TO: All Design Section Staff
FROM: Bijan Khaleghi
DATE: October 29, 2021
SUBJECT: WSDOT Scour Design Policy - Revised

This design memorandum provides revisions to the WSDOT Scour Design Policy. Bridge Design Manual Sections 7.1.7 and 15.7.1 and Figures 8.1.9-1 through 8.1.9-3 shall be replaced in entirety with the following. **This design memorandum supersedes the October 19, 2021 WSDOT Scour design policy memorandum.**

Figure 7.1.7-1 Foundation Scour Effects

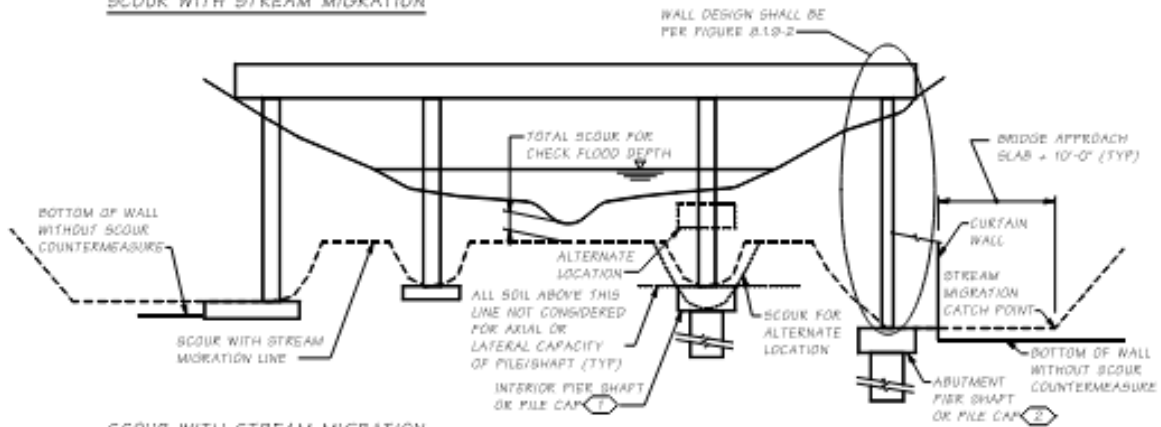
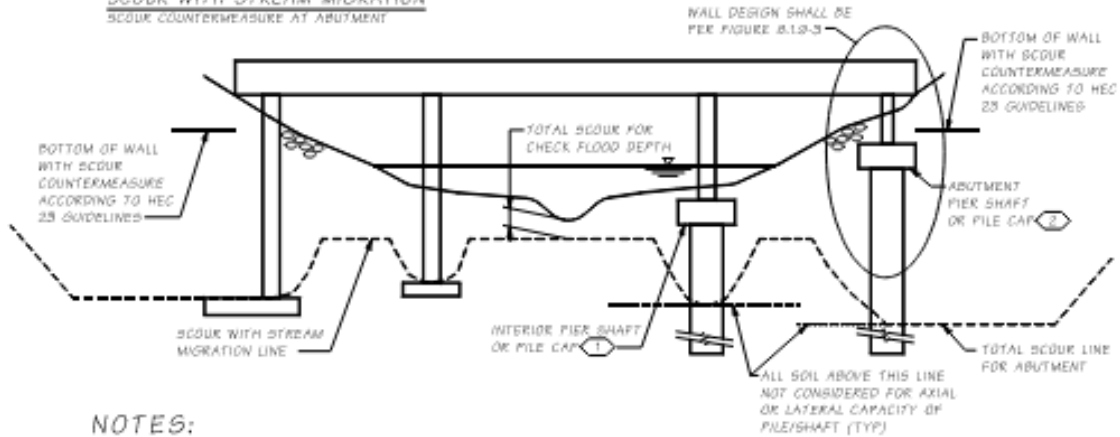
- ① INTERIOR PIER SHAFT OR PILE CAP MAY BE LOCATED ABOVE STREAM MIGRATION OR SCOUR LINE AS LONG AS THE FOUNDATION IS DESIGNED FOR THIS CONDITION. BOTH HYDRAULIC AND GEOTECHNICAL RECOMMENDATIONS SHALL ACCOUNT FOR THE EXPOSED CAP AND/OR SHAFT OR PILE.
- ② ABUTMENT PIER SHAFT OR PILE CAP MAY BE LOCATED ABOVE STREAM MIGRATION LINE IF A SCOUR COUNTERMEASURE DESIGN HAS BEEN ADDED AT THE BRIDGE END AND THE FOUNDATION IS DESIGNED FOR THE HIGHER ELEVATION. BOTH HYDRAULIC AND GEOTECHNICAL RECOMMENDATIONS SHALL ACCOUNT FOR THE EXPOSED CAP AND/OR SHAFT OR PILE. EARTH PRESSURE ON ABUTMENT SHALL BE PER FIGURE 7.17-2.

Figure 7.1.7-1 as well as the following subsections provide guidance on top of footing or pile/shaft cap elevations.

Spread footings on soil or erodible rock shall be located by the bridge designers so that the **top of footing is below total scour depths determined for the scour check flood**. Spread footings on scour-resistant rock shall be **designed and constructed to maintain** the integrity of the supporting rock.

Deep foundations such as piles or shafts may be selected by the bridge designers to protect bridges from scour. **Interior piers may have the top of shaft or top of pile cap placed above the depth of total scour at the scour check flood if the foundation is designed for this condition**. For abutments without scour countermeasures designed per most recent version of HEC 23, the top of pile or shaft cap shall be below the total scour at the scour check flood. If an abutment has a scour countermeasure design meeting the most recent version of HEC 23 guidelines the top of pile or shaft cap may be placed above the depth of total scour at the scour check flood. The hydraulic and geotechnical recommendations shall account for the exposed cap and/or shaft or pile.

Figure 7.1.7-2 Scour Effects when the Shafts below a Shaft Cap are Exposed

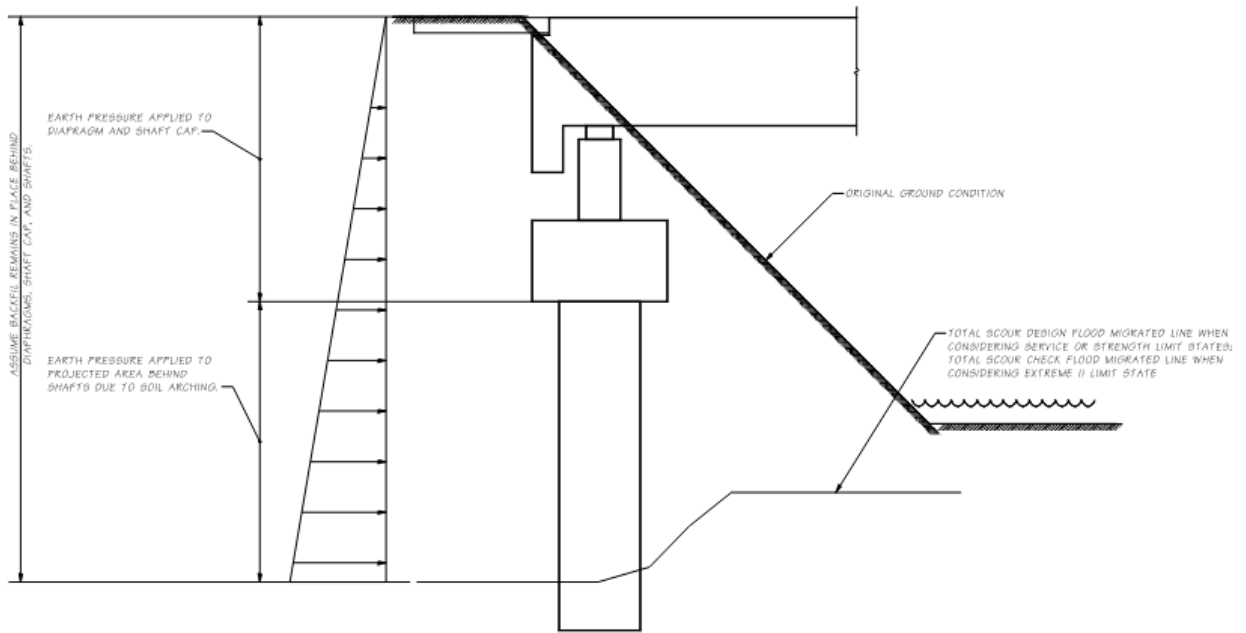
When migrated scour conditions could uncover the shaft cap and expose the supporting shafts below, soil arching conditions behind the shafts shall be assumed,

requiring the full-depth earth pressures to be applied from behind the shafts and shaft cap as shown in Figure 7.1.7-2.

Lateral analysis of the shafts shall be determined using the forces from Figure 7.1.7-2 and ignoring all soil down to the scour depth. Axial capacity of the shafts shall be determined by ignoring the soil resistance above the scour depth.

Figure 8.1.9-1 Scour without Stream Migration

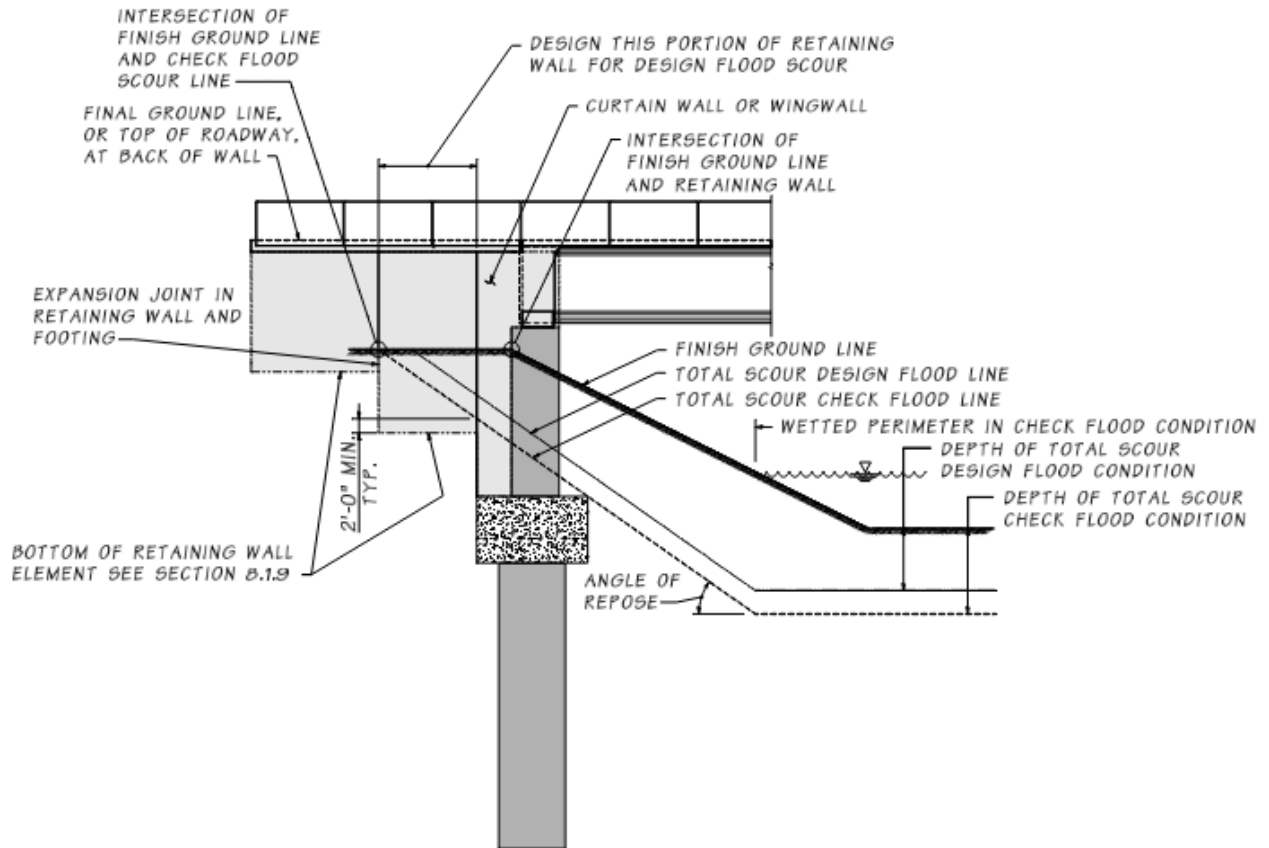
BDM Figures 8.1.9-1 through 8.1.9-3
